Important ! Change to Anti-Roost System

New Anchor Plate and Leveler Introduced

New installation diagram.

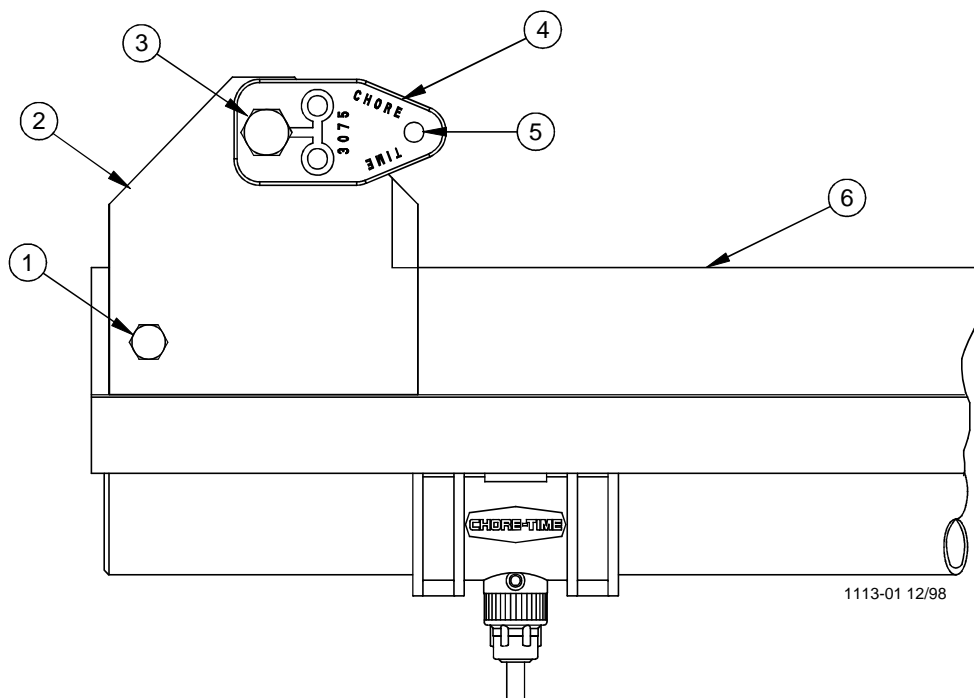
The #33824-3 Heavy Channel Anchor Hanger and #4006 Eye Bolt currently used on the Anti-Roost system will be replaced by this NEW Anchor Plate #42807 and Adjustment Leveler #3075. See MW1186D page 19 for a diagram of currently used hanger that is being replaced.

Item	Description	Part No.
1	10/24 Nut and Bolt	
2	Anchor Plate	42807
3	5/16 Nut and Bolt	
4	Adjustment Leveler	3075
5	Install shocker cable or spring here.	
6	Support Channel

New installation diagram.

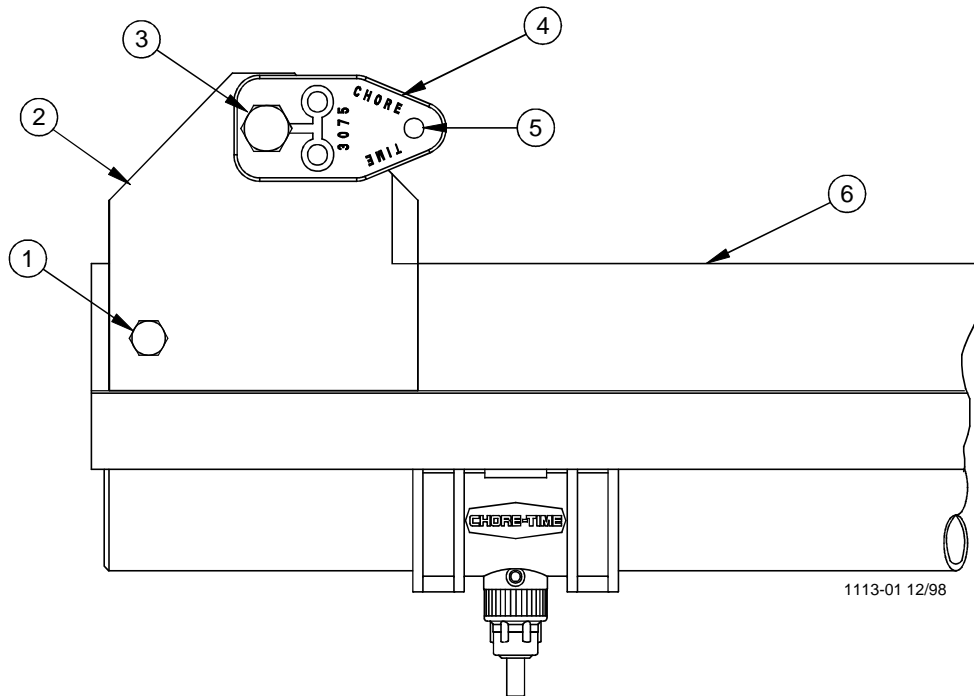
The #33824-3 Heavy Channel Anchor Hanger and #4006 Eye Bolt currently used on the Anti-Roost system will be replaced by this NEW Anchor Plate #42807 and Adjustment Leveler #3075. See MW1186D page 19 for a diagram of currently used hanger that is being replaced.

Item	Description	Part No.
1	10/24 Nut and Bolt	
2	Anchor Plate	42807
3	5/16 Nut and Bolt	
4	Adjustment Leveler	3075
5	Install shocker cable or spring here.	
6	Support Channel
